Knoll House Hotel, Studland

Proof of Evidence on Landscape

Prepared on behalf of Dorset Council

Local Planning Authority reference: P/FUL/2022/06840

Figure 4.10: Extract of LVIA Figure 6c – Screened ZTV – illustrating large area of potential visual influence of the proposals extending between Ballard Down in the south, Sandbanks and parts of Poole Harbour in the north, elevated areas of heathland to the west and most of Studland Bay to the east

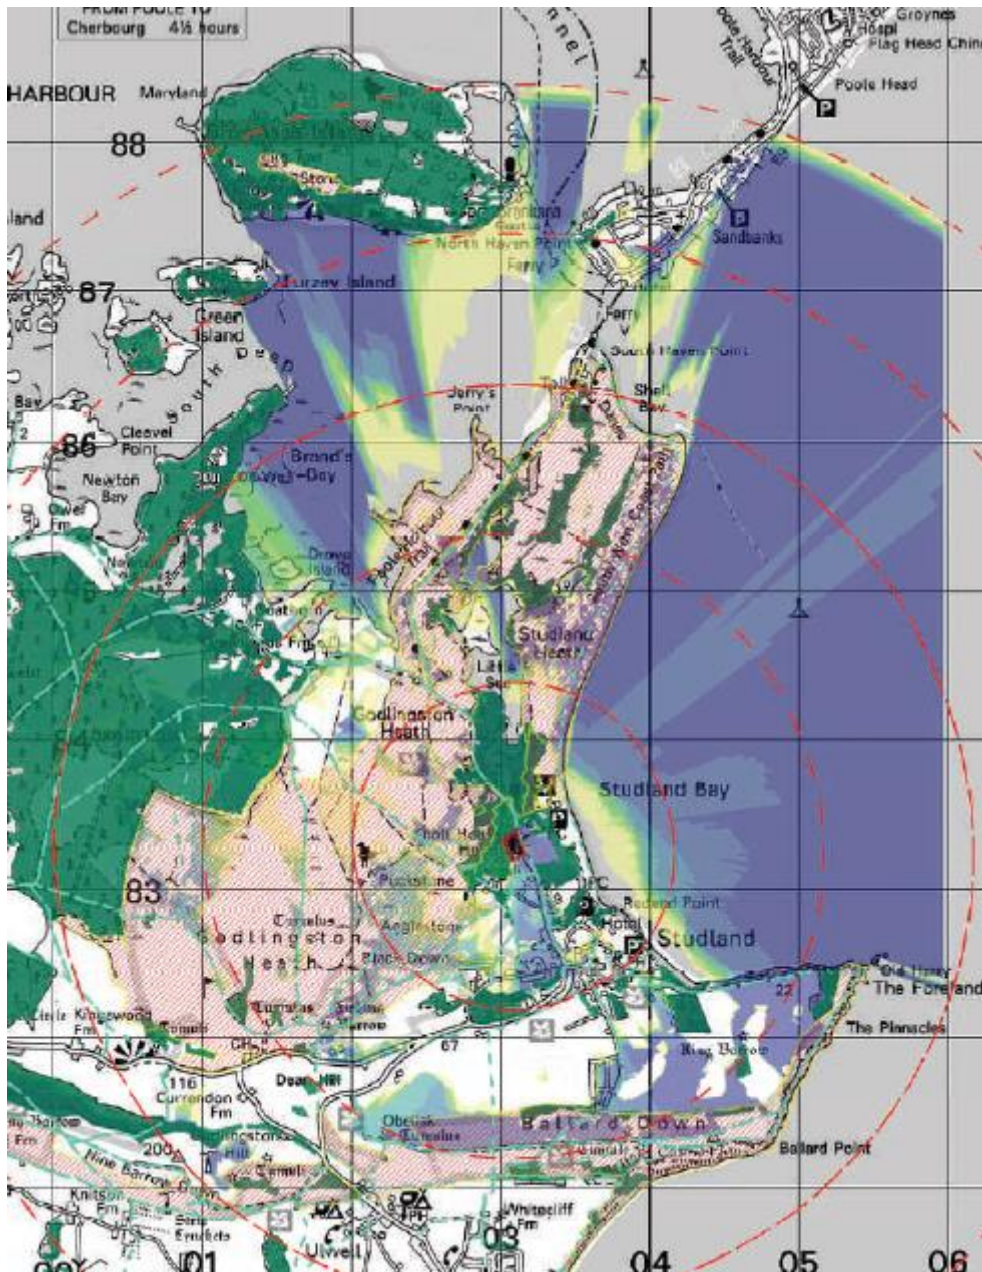
- 4.14 However, the description of the visual baseline within the LVIA has a number of omissions including, in particular:
- 4.15 **No commentary or photography is provided to illustrate night time views.** This is a significant omission as the presence or absence of lighting in the landscape influences several of the special qualities of the National Landscape including its: Dark Night Skies, Undeveloped Rural Character and sense of Tranquillity and Remoteness. It is therefore important to understand the existing light levels associated with the hotel to provide a baseline against which to understand the likely changes to light levels that would arise with the Proposed Development.

- 4.16 **No photography is provided to illustrate views from the sea.** This is again a significant omission in relation to understanding the baseline conditions for: the Special Quality of ‘Undeveloped Coastline’ for the National Landscape and the Heritage Coast; the local seascape character; and the views experienced by boat users. The LVIA identifies that the area is popular with recreational sailors, that ferry routes pass through the area and that potential effects of the proposals on seascape character and views from the sea is a relevant consideration. However, no photography of views from the water is provided. For an application for major development within a National Landscape and Heritage Coast I would have expected photography and further analysis of views from the sea to have been carried out.

Figure 6.2: Villa Section AA (CD1.026) – Example of incomplete levels information - illustrating lack of information on existing ground levels and how proposed levels tie in with existing site levels at the site boundary. Most other sections are similarly lacking in levels information

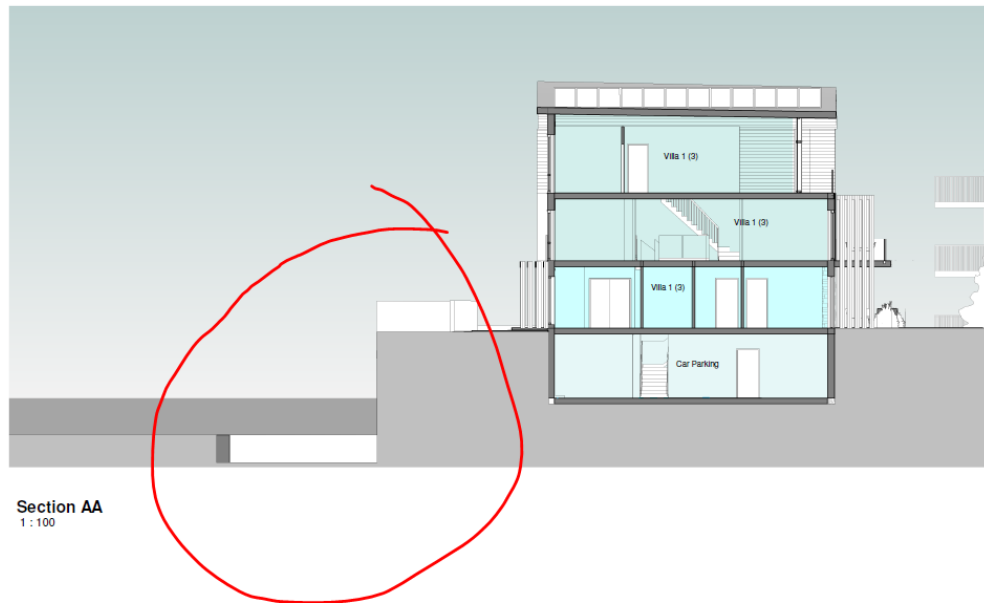
- 6.6 Whilst some limited spot heights are provided for existing and proposed levels, the application pack has a significant shortage of information on the overall earthworks strategy for the site. In particular, most site sections do not show the existing ground level, the heights of retaining walls are not given, a proposed contours plan is not provided and it is not clear in which parts of the site the ground levels will be raised and lowered and by how much. On a site of this sensitivity in a National Landscape and with trees covered by a Tree Preservation Orders, these are significant omissions.

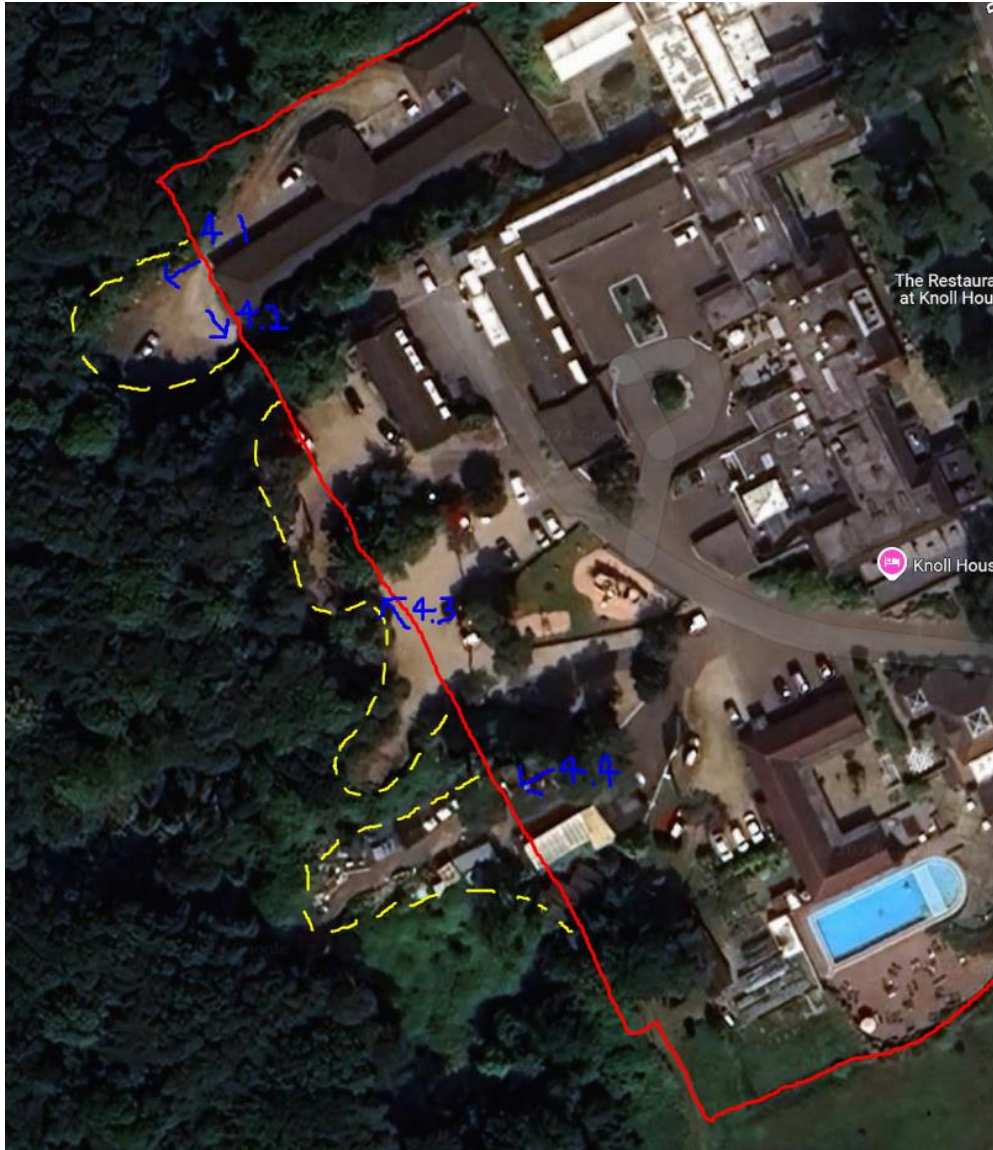
- 6.12 The red line boundary for the planning application boundary has been drawn tightly around the proposed development area. As shown in Figure 6.3 below and also shown clearly on the Demolition and Proposed Overlay drawing no 12002 revP02 (CD 1.012), the planning application boundary does not relate to the existing site boundary. A substantial part of the western side of the existing Site including large parts of the car park, a ramped access and maintenance depot lie outside of the planning application boundary. The demolition plan indicates removal of existing buildings beyond the red line but the scheme proposals do not include any works to these existing developed areas. As a consequence, the scheme fails to integrate appropriately with its setting.

Figure 6.4 – Landscape Strategy plan (CD2.001) – trees to be removed are highlighted red – all trees in western half of the site are being removed (but these are still appearing in the visualisations – see below)

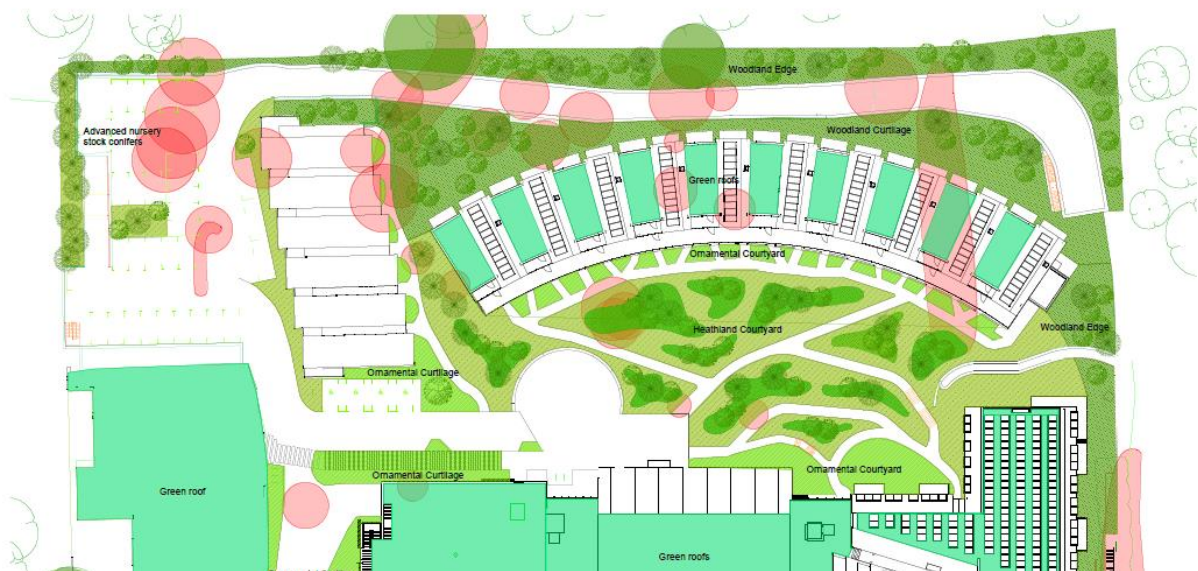
- **Visualisations incorrectly show all trees on the site (and in adjoining woodland areas) as being retained** (compare tree removal plan with baseline and visualization photos below – no change to the trees present in the view). All the vegetation in the western part of the Site is to be removed ; a total 80+¹¹ trees are being removed (including 16 pine trees). This will be a big reduction in vegetation cover but is not reflected in the visuals. As a result, the buildings appear to be more screened in the visualisations than they would actually be.

Figure 7.6 Site plan (CD2.003) illustrating 'pinch points' where building separation distances are small (as little as 8m in places) – this kind of tight layout is more typically found in built up areas and is urban in character

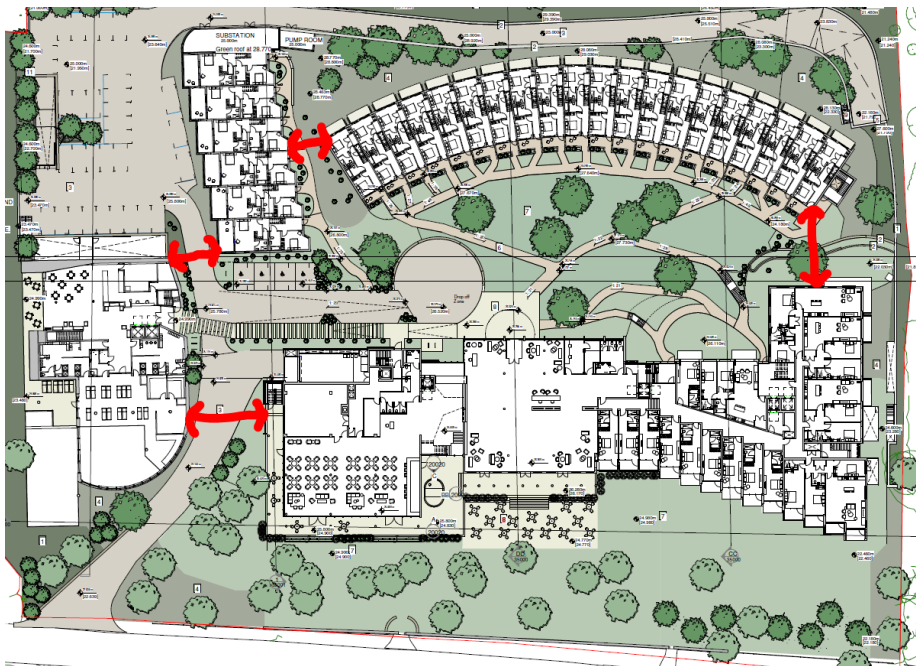
- the **increased height, scale and massing** of the proposed buildings are urban in character; the scale and form of the crescent terrace of 20 villas and the large spa building are particularly incongruous to the rural context.
- the **high density of development** on site is much greater than existing and includes little separation between some of the buildings; the density and separation distances are more suitable for an urban context than the rural context of the Site.

Figure 7.7: Extended cross section AA (CD2.005) through northern site boundary – illustrating 6m high retaining wall containing northern edge of hotel service area (equivalent height of two storeys)

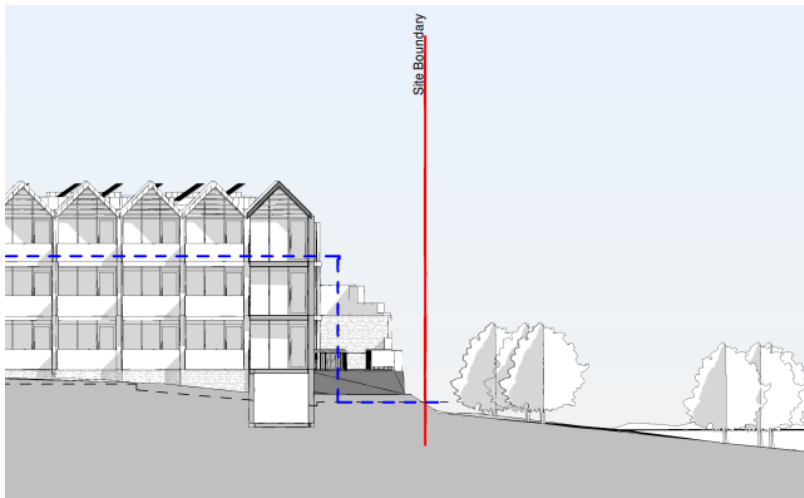
7.14 *Northern boundary* – The northern edge of the proposals is particularly poor; the development platform for the villas is set at 28m AOD but existing levels in the north -western part of the site are c. 21.8m AOD. As a consequence, a **6m high retaining wall** is proposed along the northern edge of the Site. This is illustrated in sections GG from the DAS and extended site section AA (see Figure 7.7 below)

Figure 7.9: Extended Site Section CC (CD2.005) (southern end of western boundary) – proposed access road is sunken by 4m and enclosed by high walls forming an inappropriate and poorly integrated edge to the woodland.

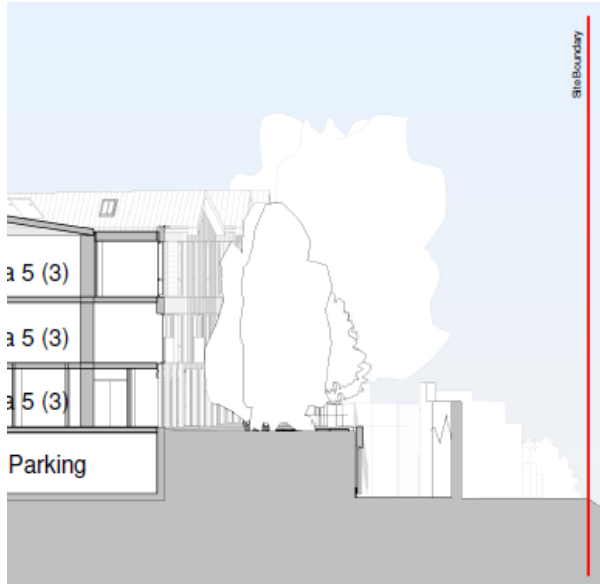
- 7.15 *Western boundary* – The western edge of the scheme is, in effect, defined by the sunken access road to the hotel basement. The narrow route is sunken by 4m at its southern end (see section below), increasing to 6m as its northern end (no section provided). Its narrow 3m width and high walls either side will form a canyon-like approach to the service area.

Figure 7.11: Tree removal plan with additional trees at risk of removal or death/severe decline due to proximity to proposed buildings, structures or significant level changes – illustrating significant additional loss or reduction of tree cover is likely over and above that identified in the AIA

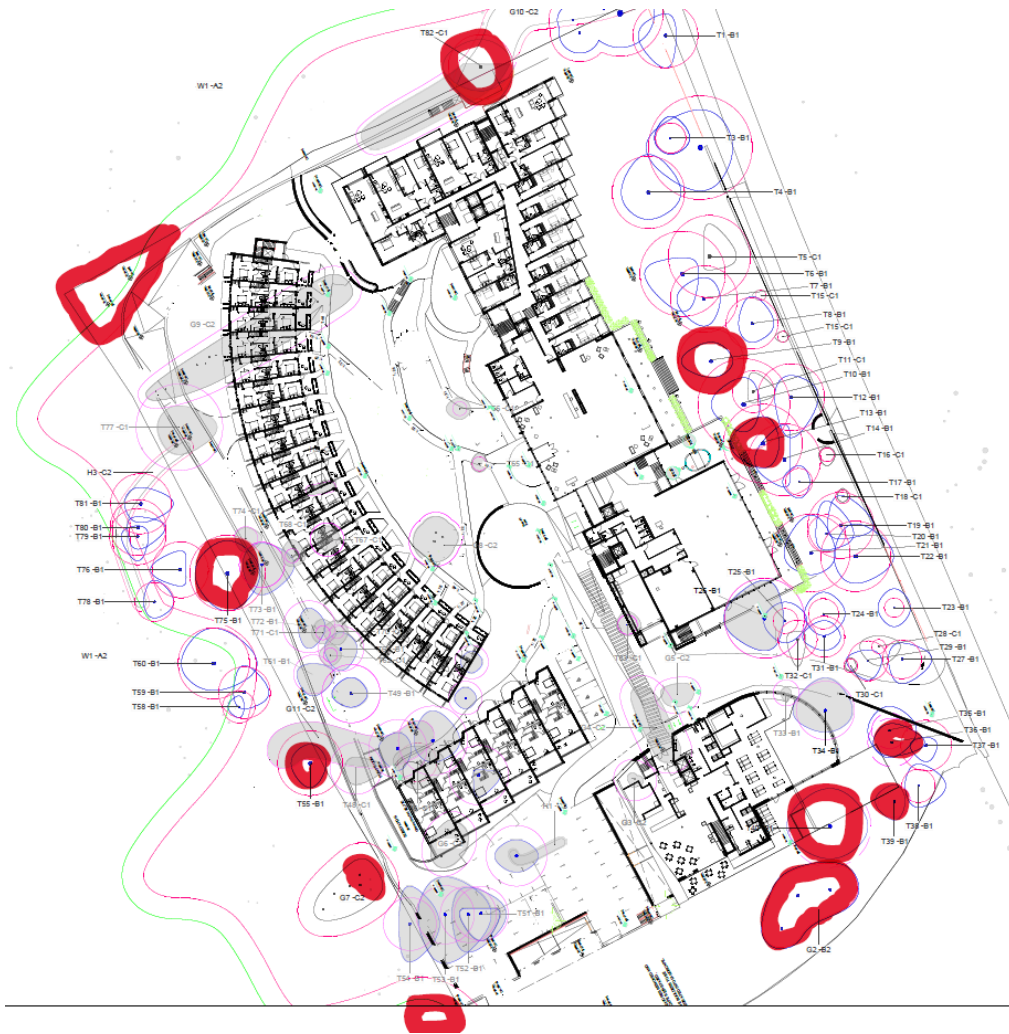
- 7.20 In addition to the trees identified in the AIA for removal, there is also a significant risk of additional tree loss and/or crown reduction, due to the proximity of proposed buildings, retaining structures and earthworks to existing trees. I acknowledge that this is essentially a question of arboricultural expert opinion and I defer to the evidence of Mr Douglas on this issue, but based on his evidence, I understand there are additional trees at risk of removal or death/severe damage. I have indicated these below on Figure 11 below; this includes a further five trees at least which are covered by a tree preservation order (T40, T36, T75, T21 and T81).
